RE: 400 - 402 Blossom Hill Road

I reviewed the drawings, evaluated the site context and prepared an initial review letter in November of last year. My comments and recommendations on the new drawings are as follows:

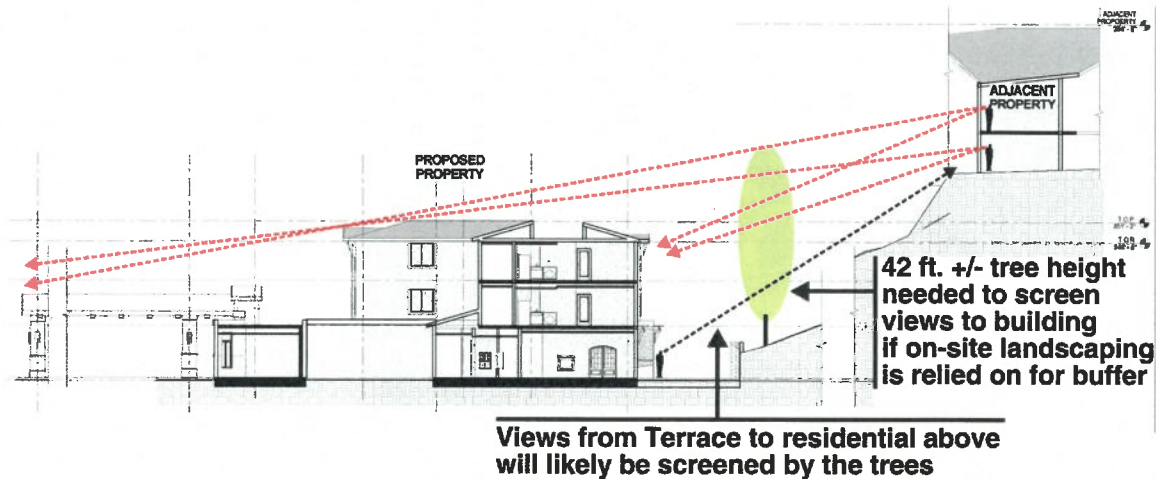
The proposed new building would be sited at the eastern edge of the site a little closer to the property line than the existing buildings on the site - see the applicant-provided aerial photo site plan below.

1. The construction of the new building would necessitate the removal of several large trees along the eastern boundary of the site - see illustration below.

I am unable to evaluate whether the remaining trees on the adjacent slope would be adequate to screen views to the new three-story building from the multifamily homes above. The applicant is proposing 10 Ft. - 15 ft. tall native trees& shrubs along the eastern edge of the property. These proposed trees would be insufficient to screen views to the new building's roof areas. Trees on the project site would likely need to be in the 40-foot range to provide screening of the roof and mechanical equipment well of the new structure- see illustration below.

Recommendation: Condition the project to have all roof equipment match the building color to lessen the visual impact from above.

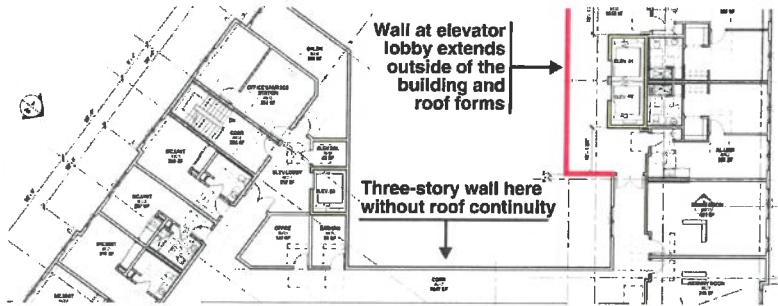
2. The depth of the landscaping where guest rooms abut the sidewalk and parking lot may not be enough to mitigate the privacy and headlight intrusions. The space for landscaping between the windows and the sidewalk edge ranges in width from 14 inches to 48 inches. The sketch on the previous page shows some minor landscaping below the windows, but the landscape plan does not show any landscaping along the sidewalk/parking lot edge.

Recommendation: Explore alternatives to mitigate the privacy and light intrusion.

Stucco elevator lobby protruding outside of upper floors building roof form is awkward

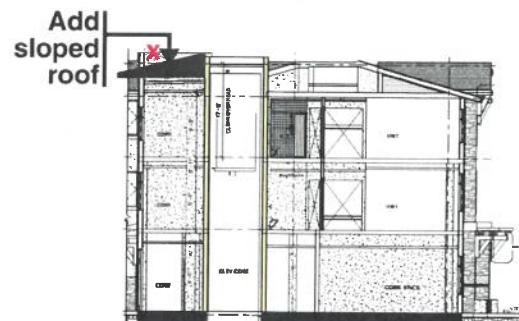
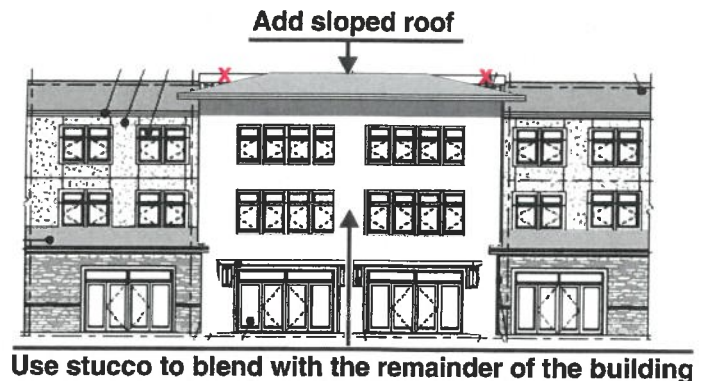
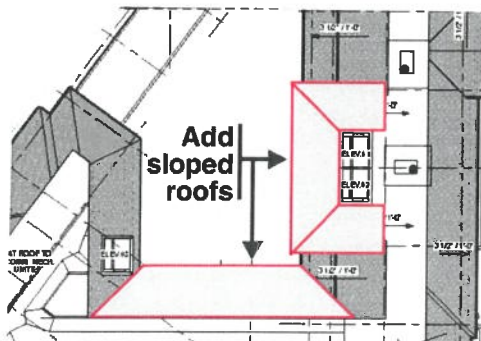
- The location of the elevators necessitates a jog in the corridor on the upper levels which pushes a box enclosure outside of the building and roof forms. This condition is not consistent with the overall design of the building. The condition is created by the shallower building depth on upper floors from the east wall to the corridor than is provided on the first floor. Therefore, the corridors are not aligned vertically. Also within this courtyard, the roof overhang does not continue across the south wall.

- Add a sloped roof on the elevator.*
- Use stucco on the elevator element to blend with the remainder of the building.*
- Continue the sloped roof around on the south wall of the courtyard.*
